OREGON TRAFFIC CONTROL DEVICES COMMITTEE

Meeting Agenda

Manual on Uniform Traffic Control Devices

Oregon Supplement to the 2009 Edition

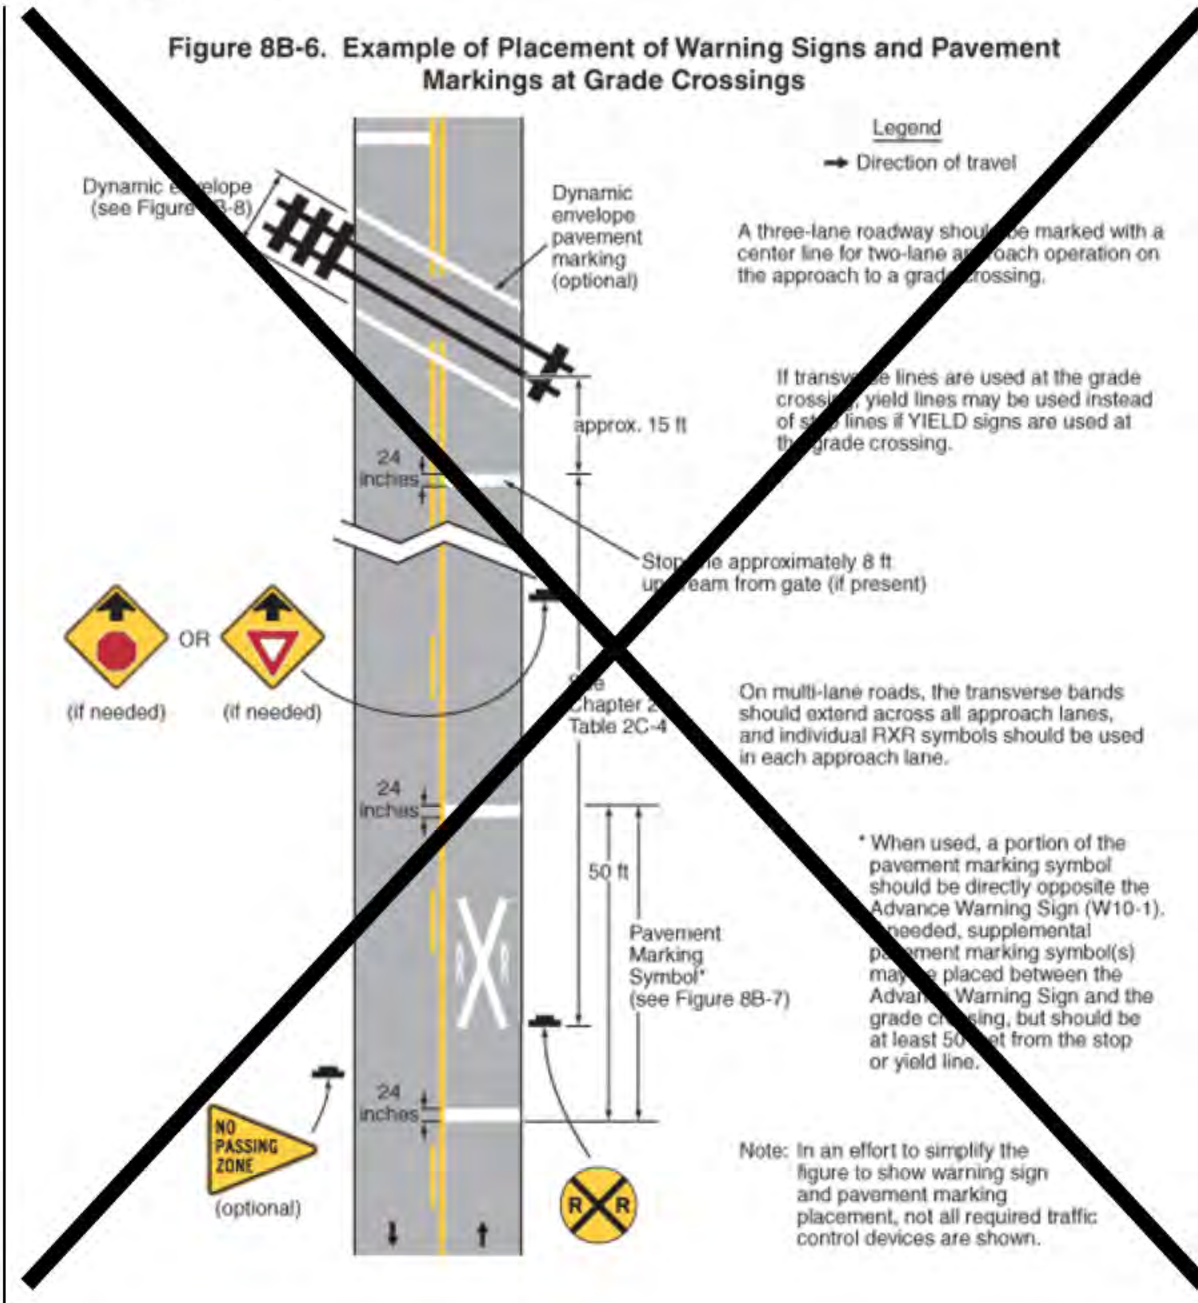
If a yield line is used, it should be a transverse line (see Figure 3B-16) at a right angle to the traveled way and should be placed no closer than ~~45~~ 12 feet in advance of the nearest rail (see Figure 8B-7).

Figure 8B-6(OR). Example of Placement of Warning Signs and Pavement Markings at Grade Crossings

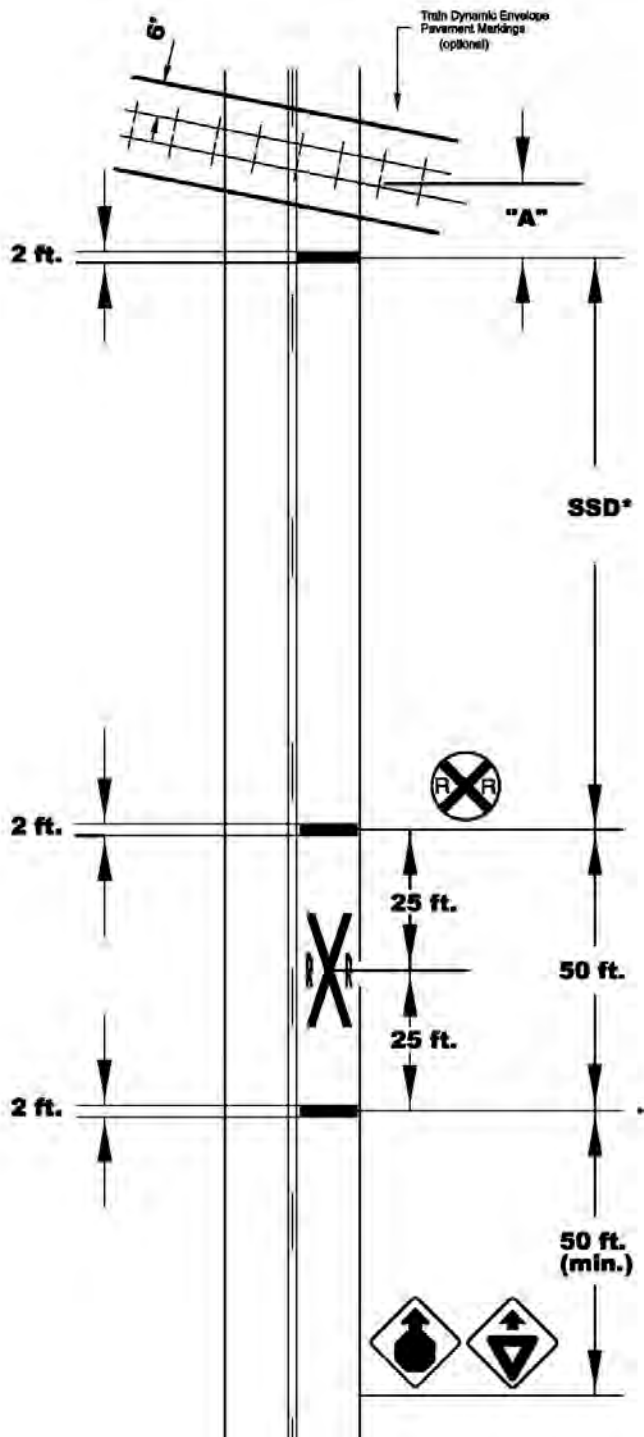
[Delete Figure 8B-6:]

[Insert Figure 8B-6(OR):]

The design and location of signs shall comply with the provisions of Part 2. Railroad advance warning signs shall be located in accordance with Figure 8B-06(OR) based upon the safe stopping distance found in Table 1 of OAR 741-100-0020. The design and location of pavement markings shall comply with the provisions of Part 3. Stop lines and railroad advance warning pavement markings shall be located according to Figure 8B-06(OR) in accordance with the Crossing Order issued by the Rail Division of the Department of Transportation.

The placement of the Highway-Rail Grade Crossing Advance Warning (W10-1) sign shall be in accordance with Figure 8B-6 (OR) and Table 1 of OAR 741-100-0020~~Section 2C.05 and Table 2C-4.~~

Figure 9B-4(OR). Guide Signs and Plaques for Bicycle Facilities**Section 9B.21 Bicycle Route Signs (M1-8, M1-8a, M1-9)**

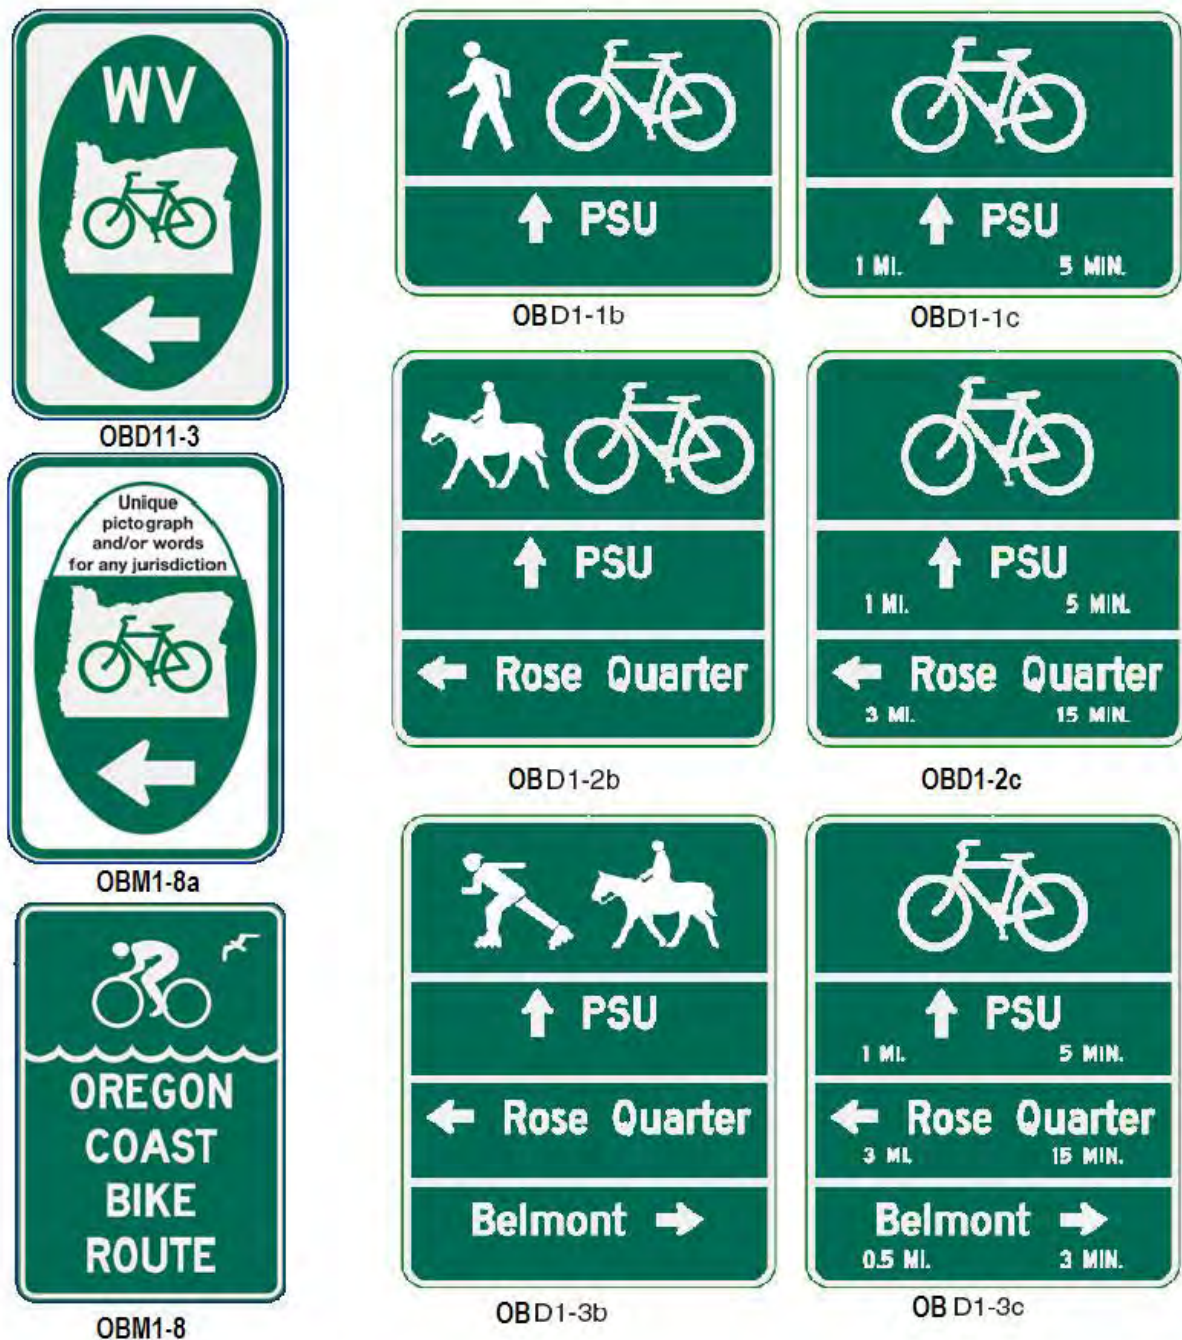
[Insert Figure 9B-4(OR):]

State and local agencies in Oregon developed design details for Bicycle Guide signs prior to their introduction in the MUTCD. Examples of these signs are shown in Figure 9B-4(OR) but are not exclusive of such examples.
